APPEAL SUMMARY

Status: Decision Rendered - Reconsideration of ID 16413

Appeal ID: 16560	Project Address: 1314 NW Glisan St
Hearing Date: 2/28/18	Appellant Name: Anne Marie Kuban
Case No.: B-002	Appellant Phone: 5032359400
Appeal Type: Building	Plans Examiner/Inspector: David Bartley
Project Type: commercial	Stories: 2 Occupancy: A-2, B Construction Type: V-B
Building/Business Name: Andina Restaurant	Fire Sprinklers: Yes - Throughout
Appeal Involves: Reconsideration of appeal, occ Change from A2, B, M to A2, B	LUR or Permit Application No.: 17-266543-CO
Plan Submitted Option: pdf [File 1]	Proposed use: Restaurant

ANDINA RESTAURANT
SEISMIC UPGRADE AND CHANGE OF USE
1314 NW GLISAN
PORTLAND, OR 97209

G0.5

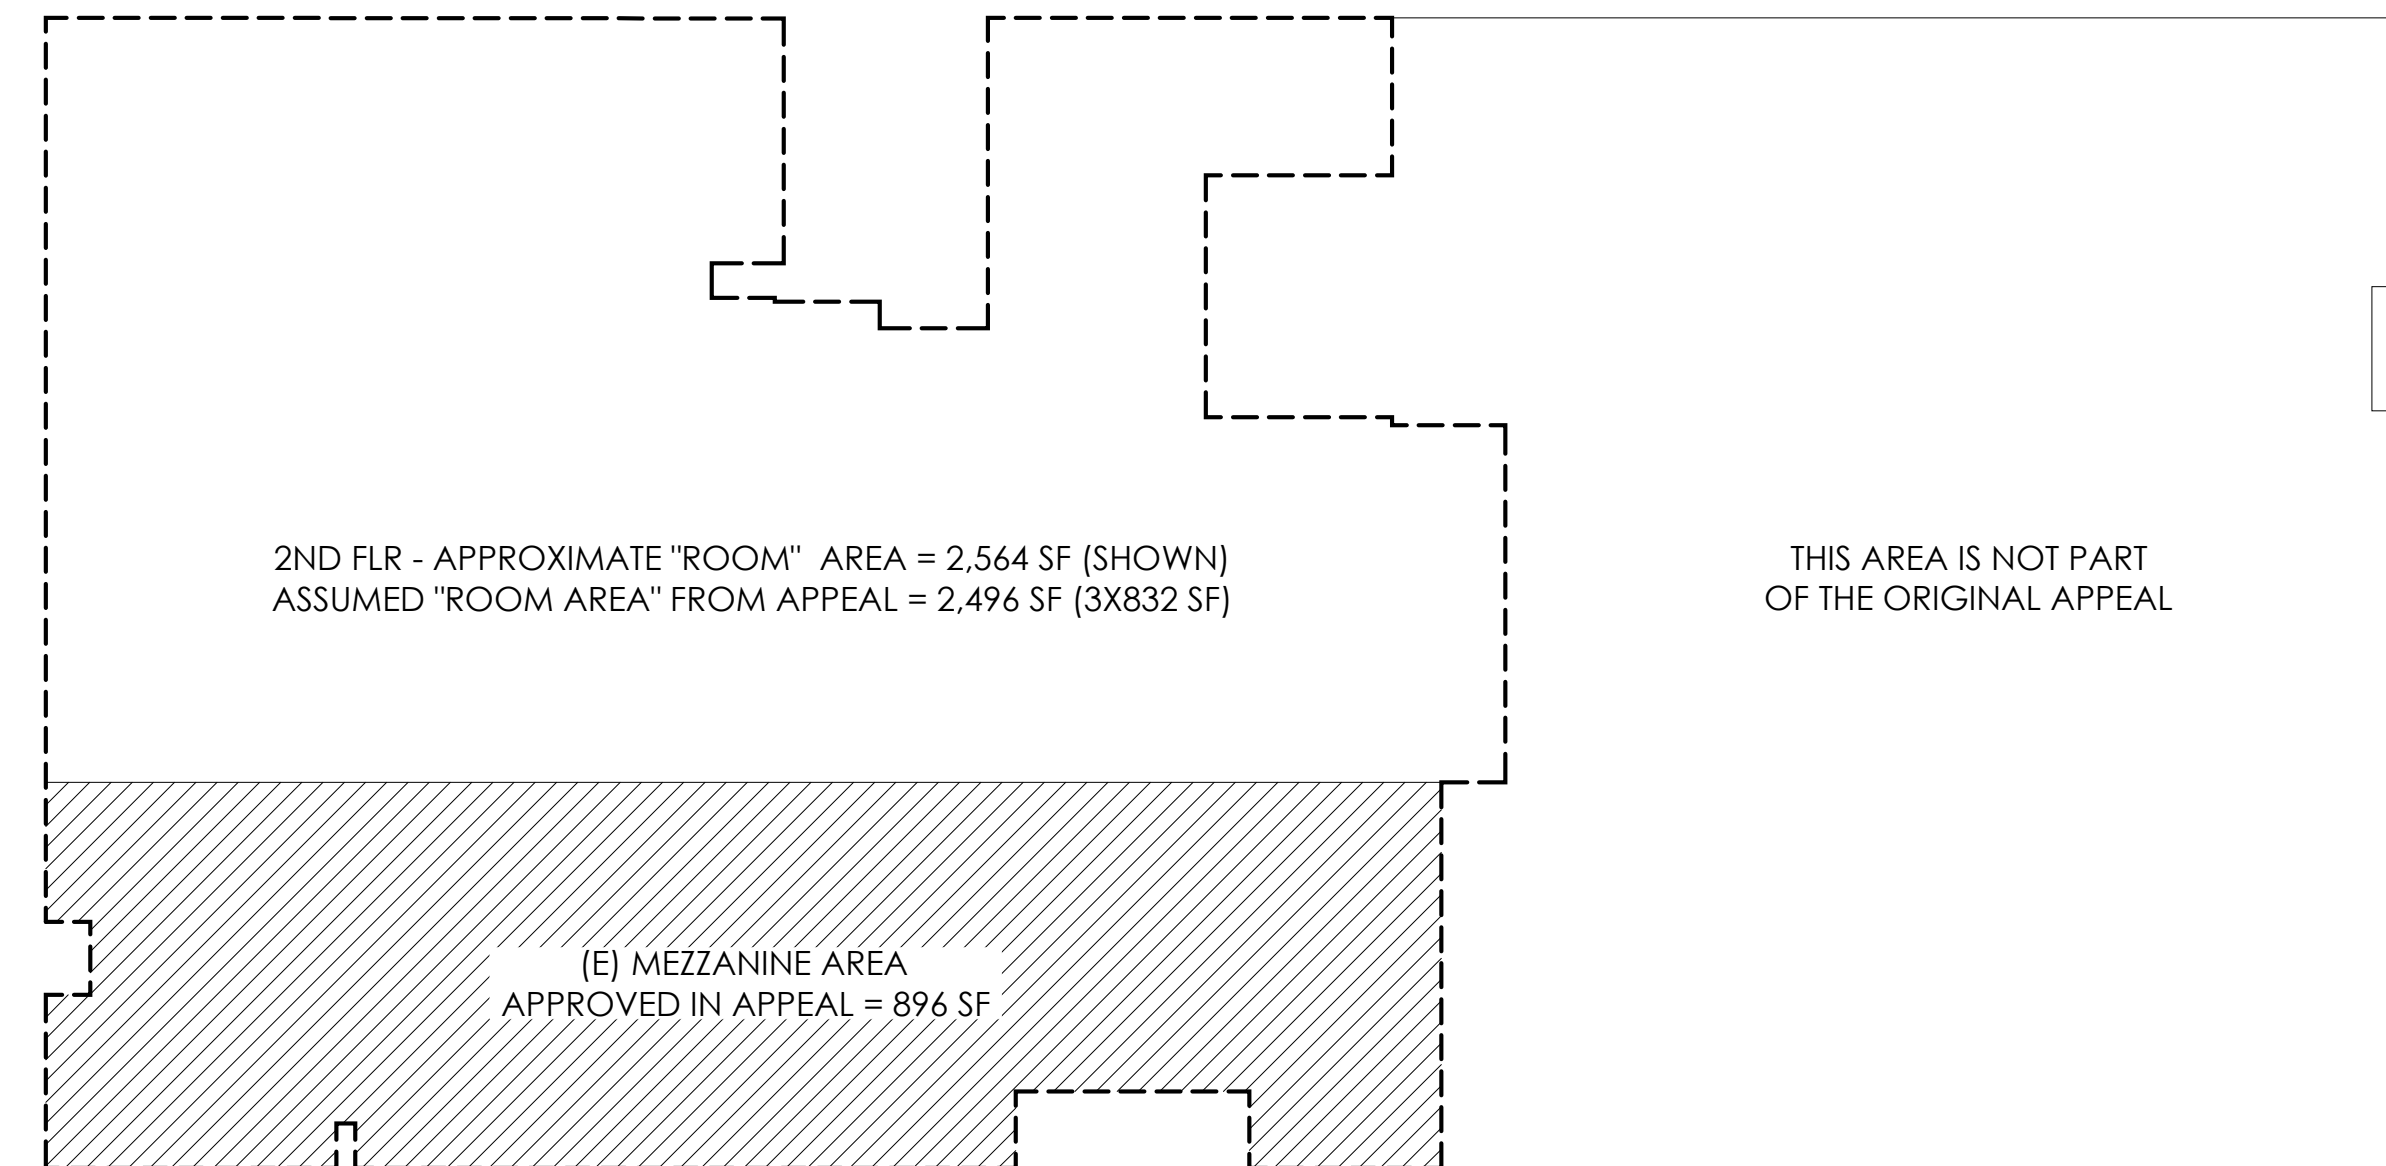
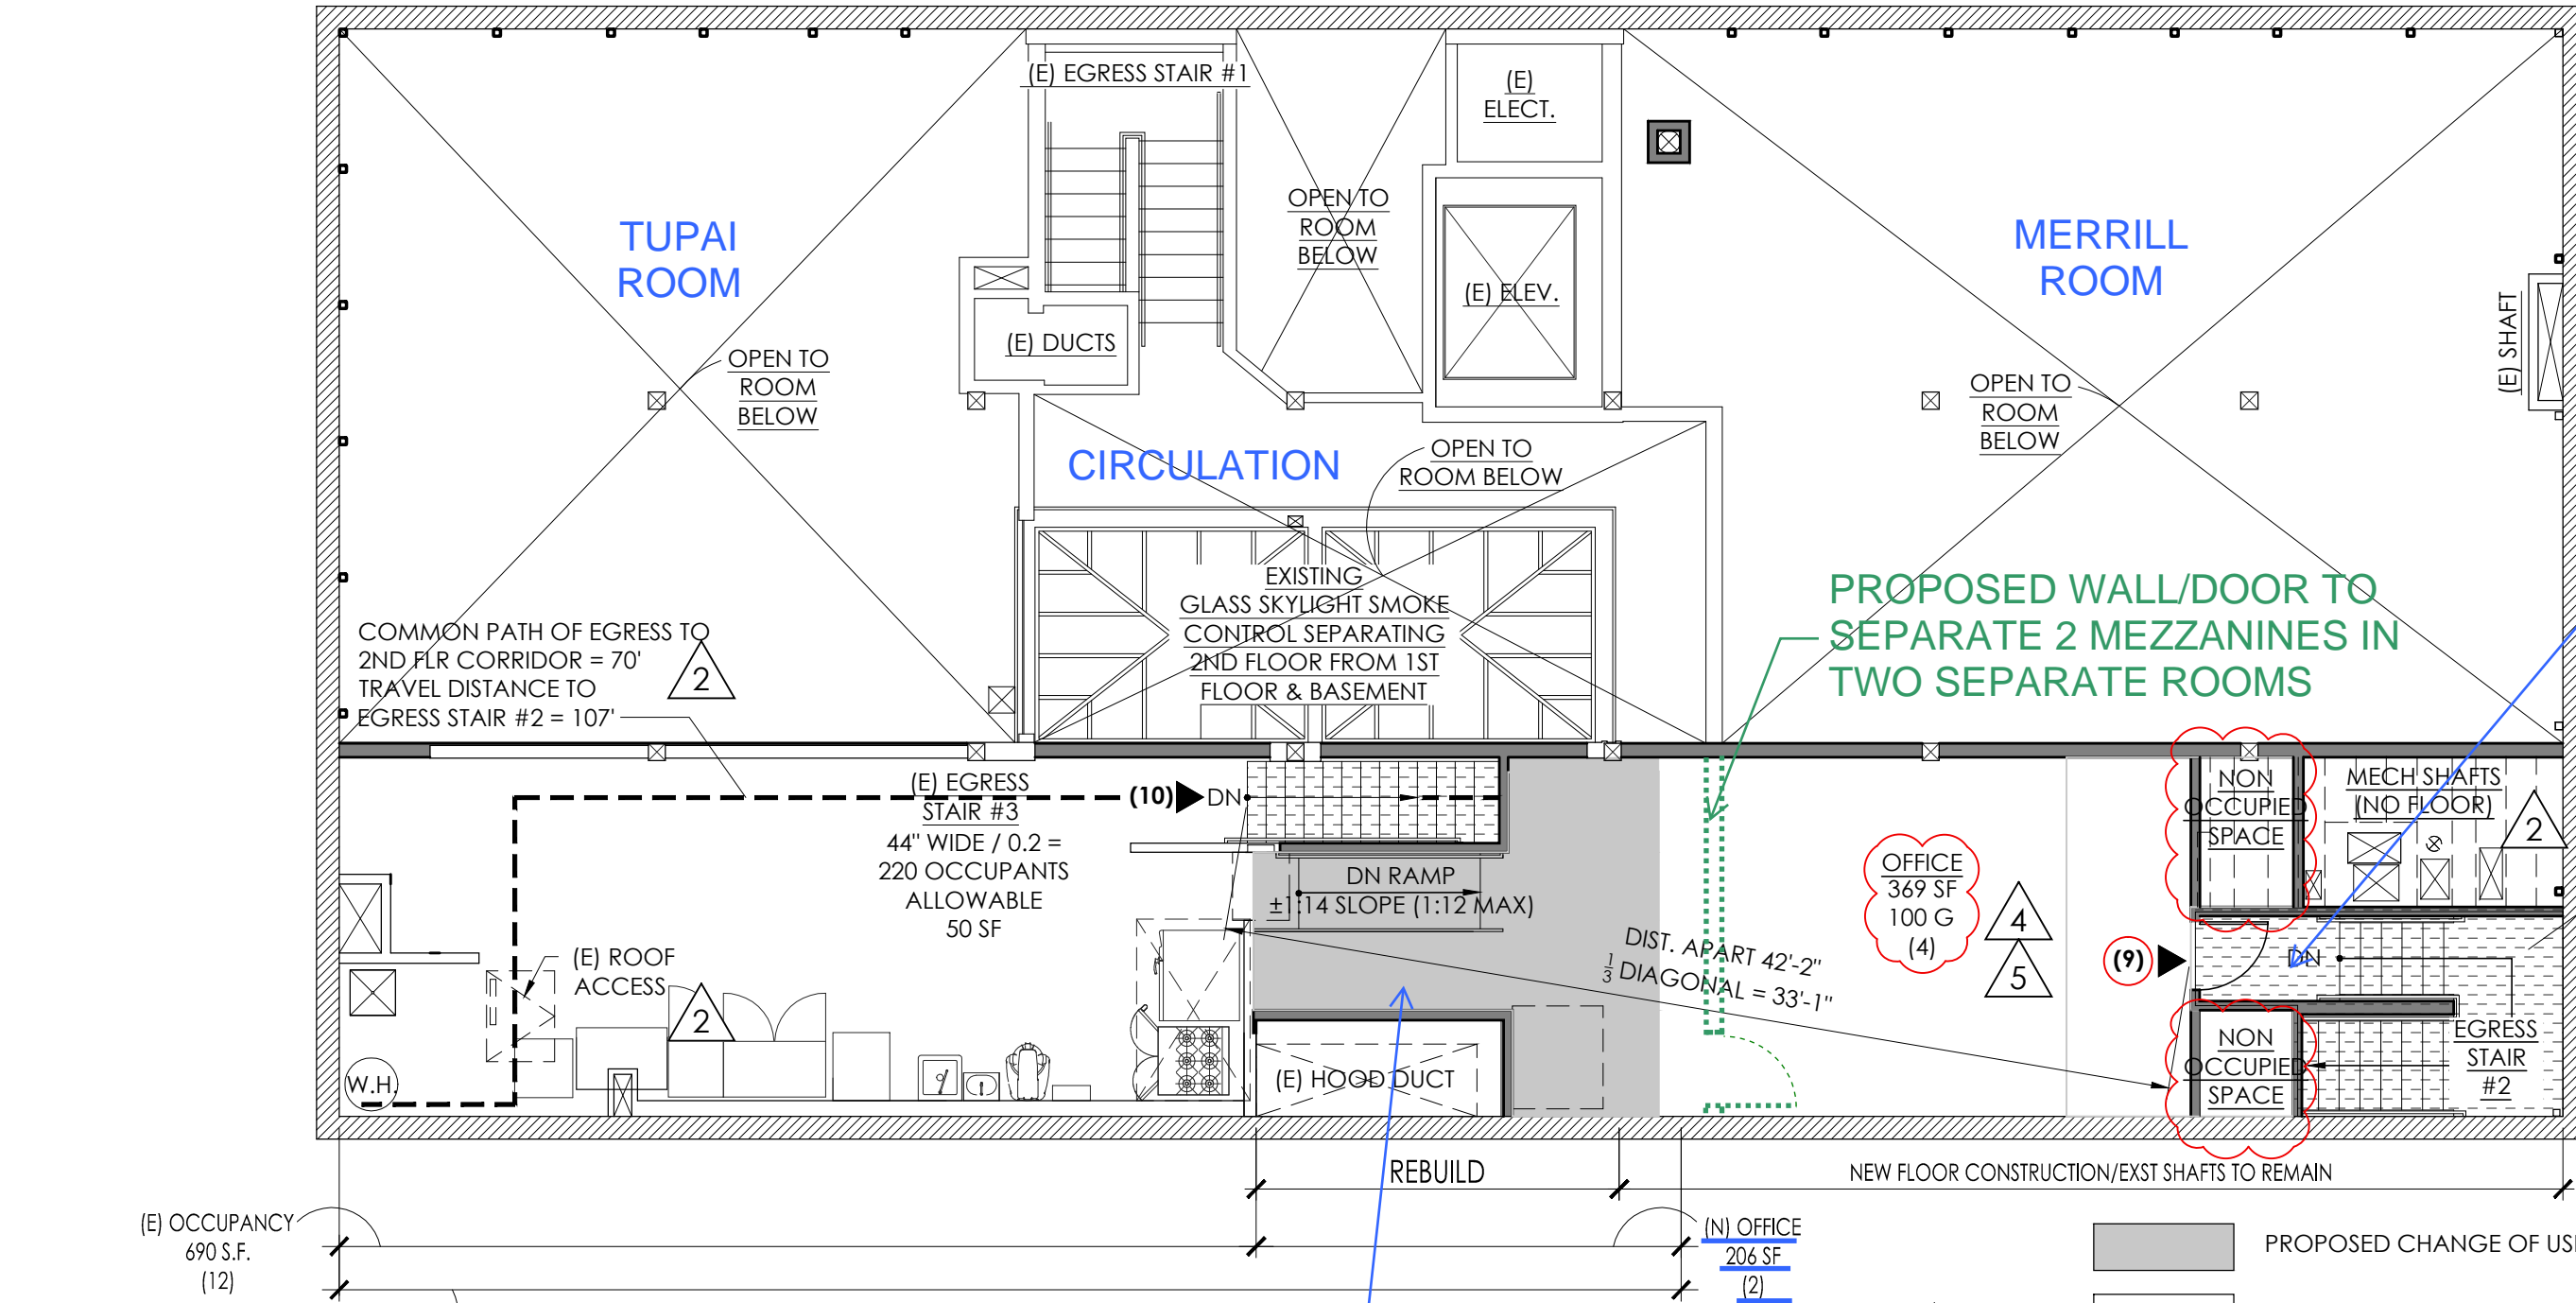
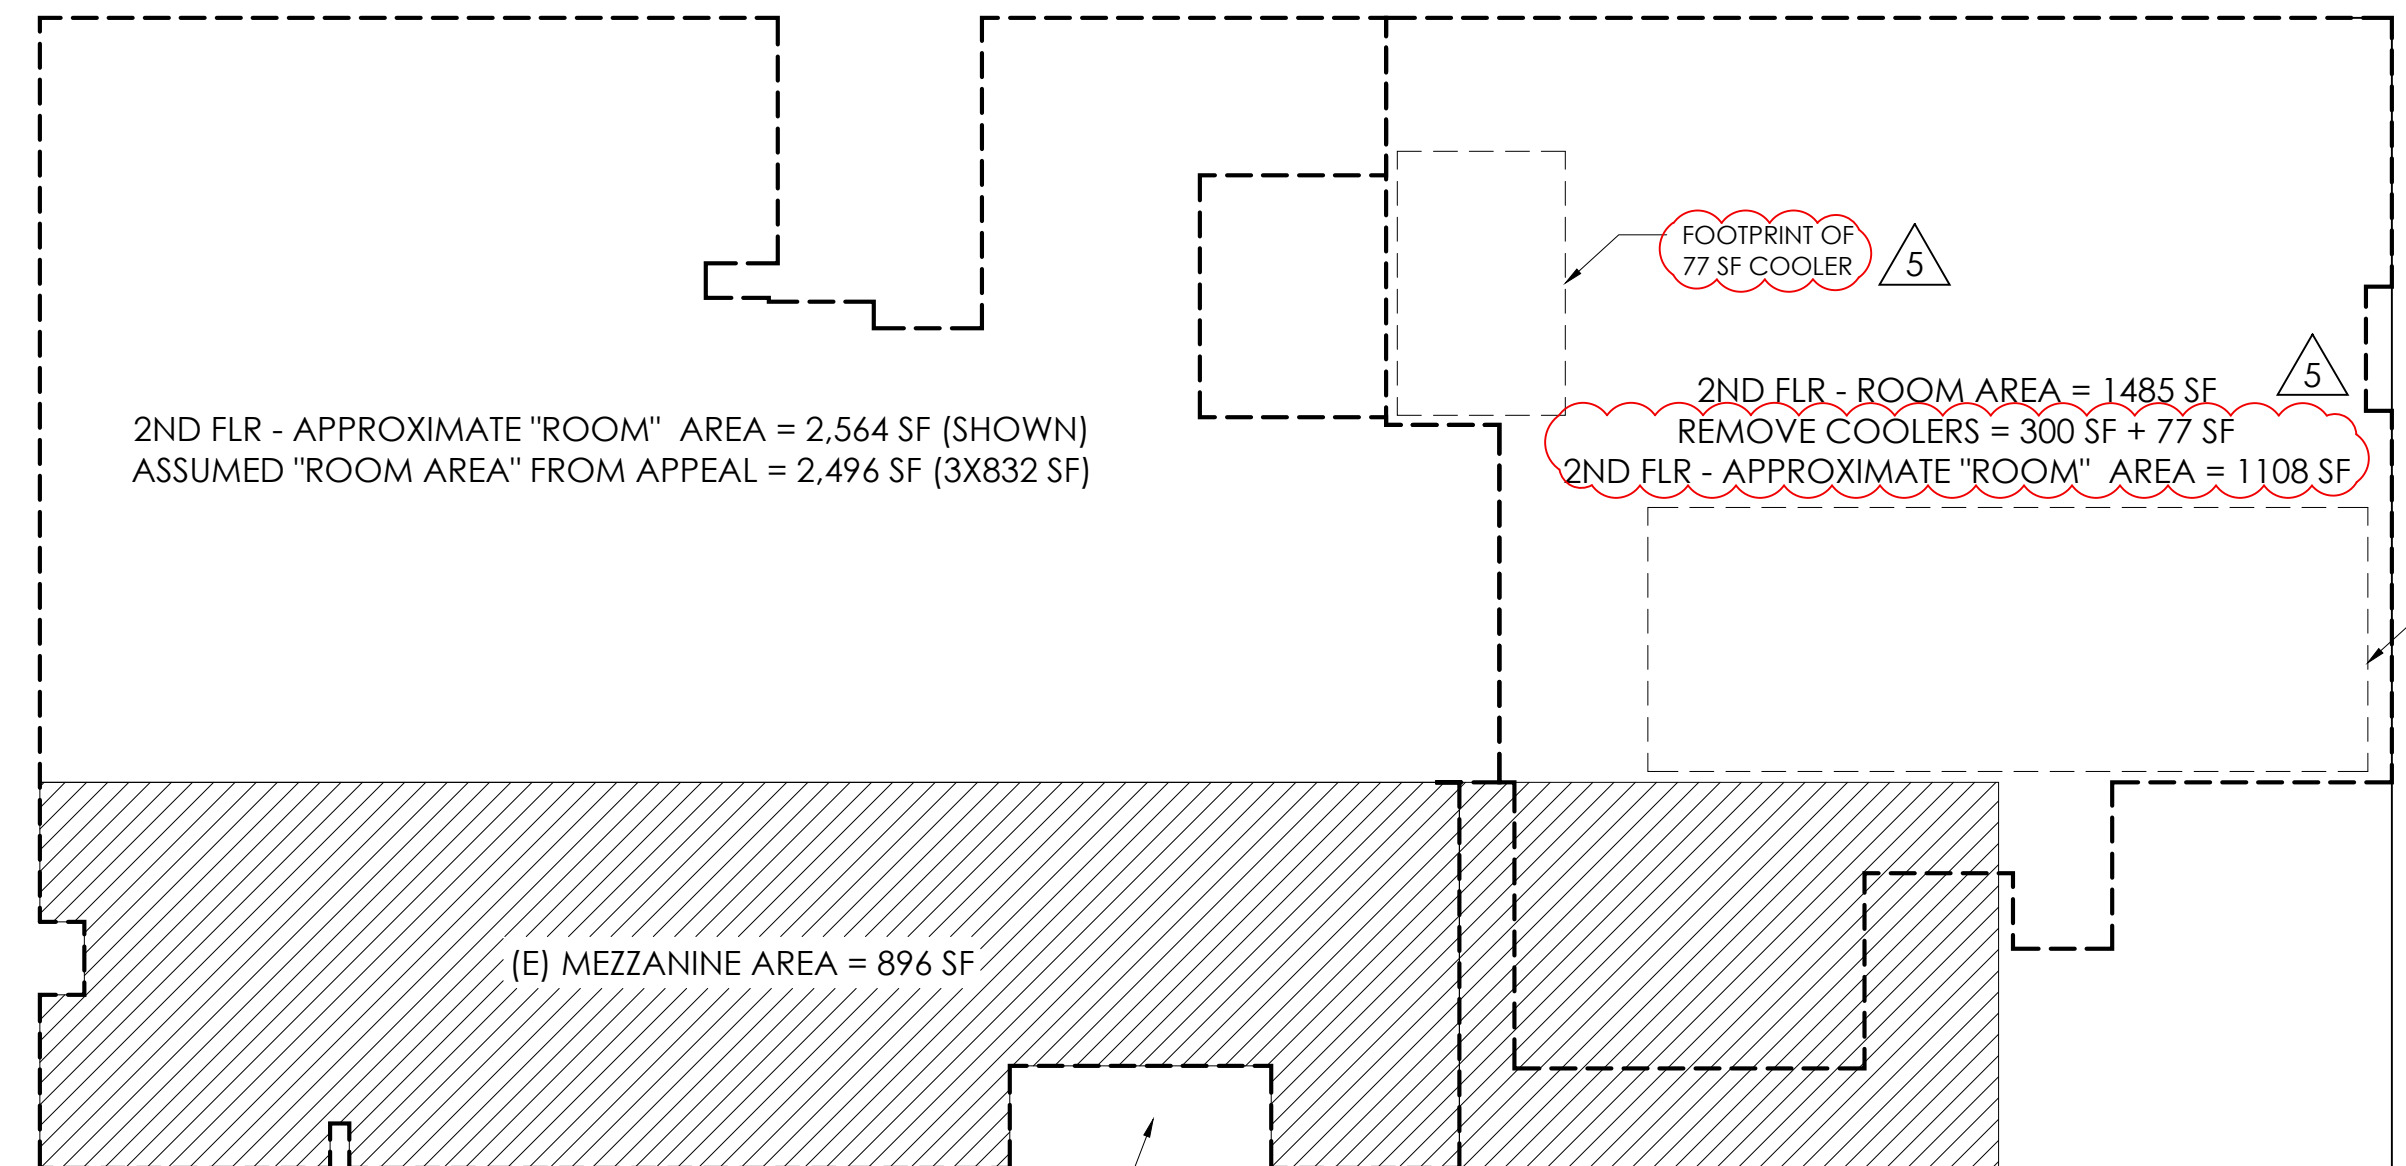
The planchecker indicated that the revised mezzanine design... "The proposed changes do not resolve the fact that the 2nd floor of the building is not one connected room. A mezzanine exists within a room, and is limited to being 1/3 of the area of that room. The existing mezzanine was appealed in 2005 to be slightly more than 1/3 of the room it was in (the banquet room). That situation has not changed. The 2nd floor is still separated into separate rooms". As a result of this interpretation, the planchecker is indicating that we need to place a wall and a door to separate the 2 mezzanines because they open into 2 different spaces. Please see mark-up on G0.5

Whether or not we can "reuse" Appeal 1543 provisions, the current design meets the letter of the code by having the current mezzanine design equal to 1/3 the area of the room(s) below.

Information on G0.5 is annotated in BLUE.

In response to the second item of concern, OSSC 505.2.1 does not prohibit multiple rooms or spaces on a floor having mezzanines. Also this Section states that ...the aggregate area of a mezzanine or mezzanines... indicating a projects could have more than one mezzanine.

The proposed wall and door separating the mezzanine has no value as a fire or smoke separating device; it would not have to be rated or follow smoke provisions in the code. It is dividing a space of the same two occupancies.

Information on G0.5 is annotated in GREEN.

- 1. Mezzanine area greater than one third of the room it is open to: Denied. Proposal does not provide equivalent Life Safety protection.**
Appellant may contact Jody Orrison (503 823-4539) with questions.
- 2. Mezzanine openness to the room it is within: Denied. Proposal does not provide equivalent Life Safety protection.**
Appellant may contact Jody Orrison (503 823-4539) with questions.
